## Route Access Condition Notice

# 15-00019

<b>Distributed To:</b>	ARTC Website
<b>Distribution Date:</b>	12-06-2015
<b>Requested By:</b>	Gary Templeton
<b>Subject:</b>	Goodwood Grade separation
<b>Effective Period:</b>	12-06-15 – Until Published
<b>Amendment Type:</b>	Permanent (to be added to RAS)

Commissioning of Goodwood Grade separation

## D3-Wolseley to Mile End

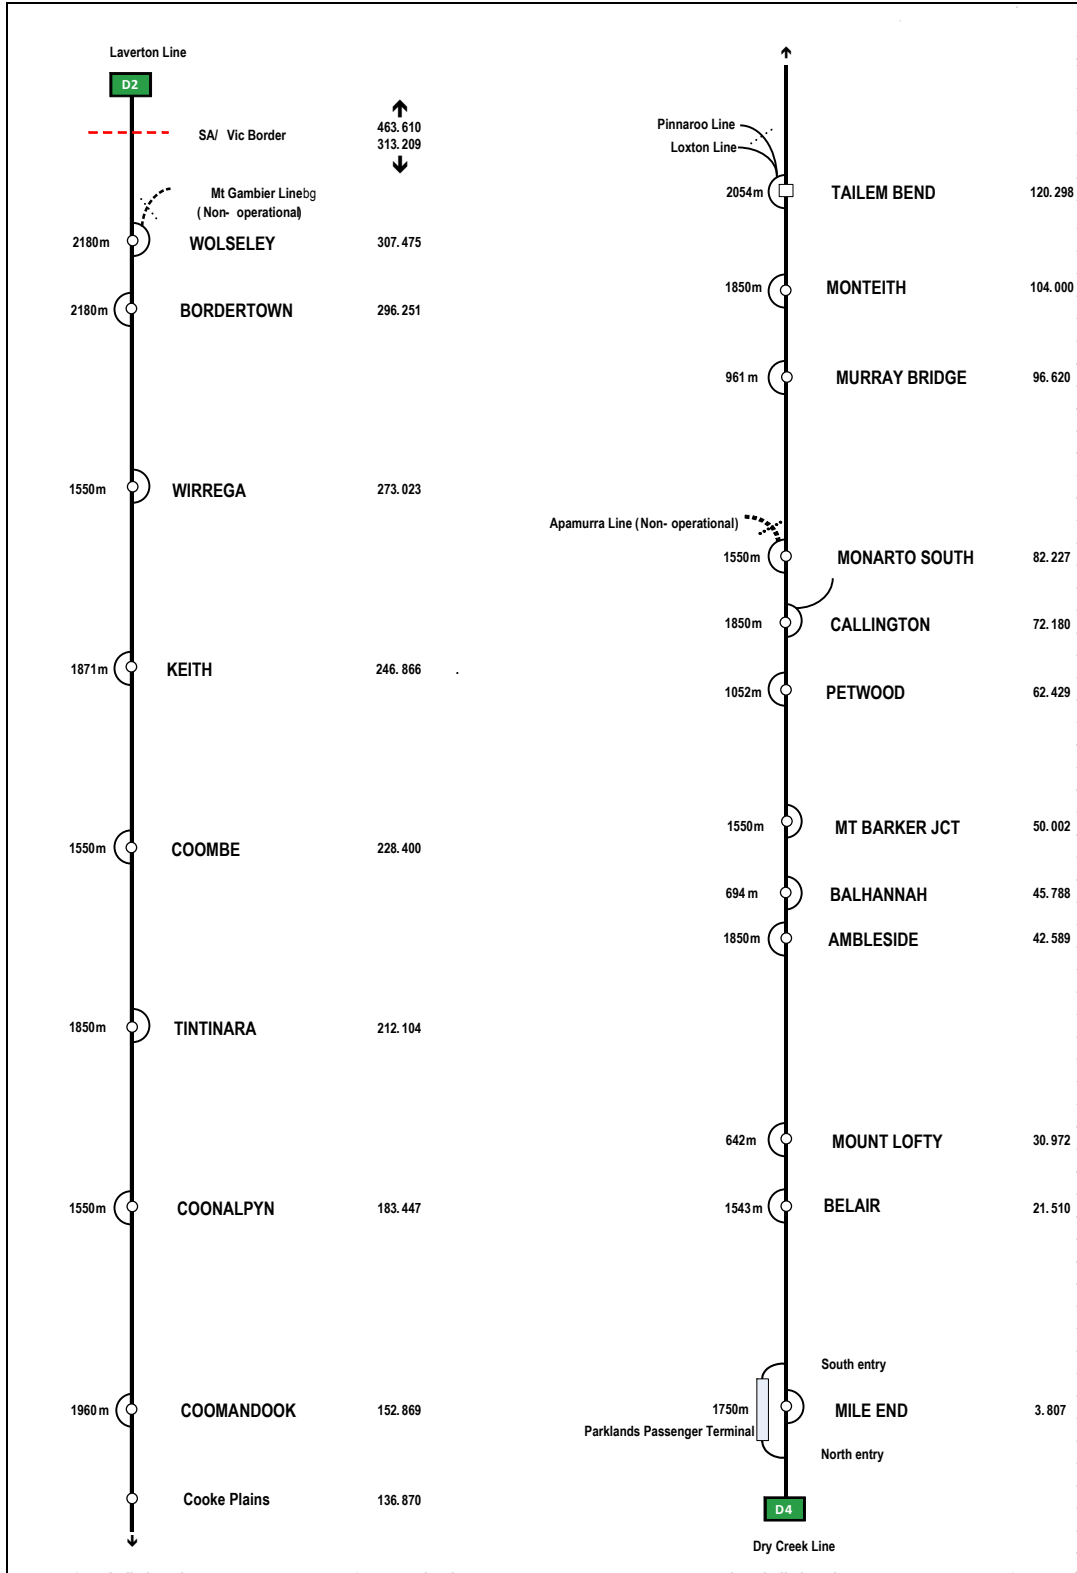
**Line Section:**      Wolseley to Mile End

**Kms:**                                      3.590 km – 31.340 km

MILE END – WOLSELEY			
LINE SEGMENT	EXCEPTION TO MAXIMUM SPEEDS LOCATION		RESTRICTED SPEED
MILE END	3.590 KM	3.930 KM	40
	3.930 KM	5.190 KM	90
COUNTDOWN DISTANCE MARKER BOARDS ALSO INSTALLED ON APPROACH TO NR4			
GOODWOOD JUNC	5.190 KM	8.310 KM	90
	8.310 KM	8.840 KM	60
	8.840 KM	11.240 KM	90
	11.240 KM	12.830 KM	70
	12.830 KM	19.750 KM	60
	19.750 KM	21.800 KM	55
BELAIR	21.800 KM	23.020 KM	75
	23.020 KM	31.340 KM	50
